SI B51 36 15
Body Equipment

Service Action: Repair the PVC seam on the left rear light

F82 (M4 Coupe)

CORRECTION

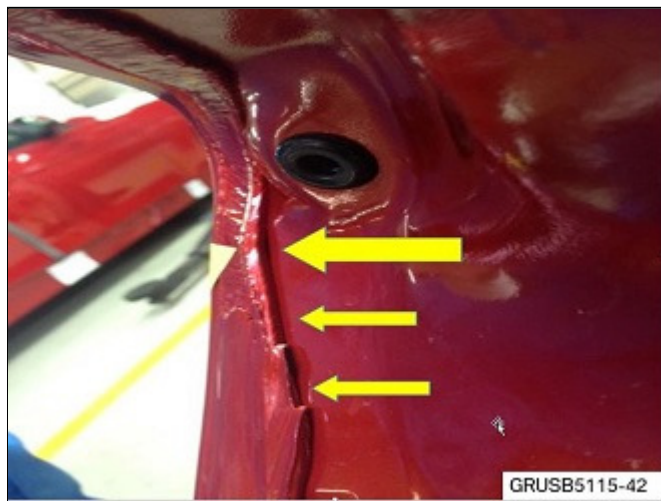
The left rear light PVC seam may not have been applied properly and may be leaking.

The PVC seam was not applied correctly and can cause water leaks.

Remove the left tail light and properly apply the PVC sealer.

2. Seal the area of the PVC seam that shows waviness or is incomplete.

3. Do not remove the existing PVC seal and only apply PVC sealer to the wavy area.
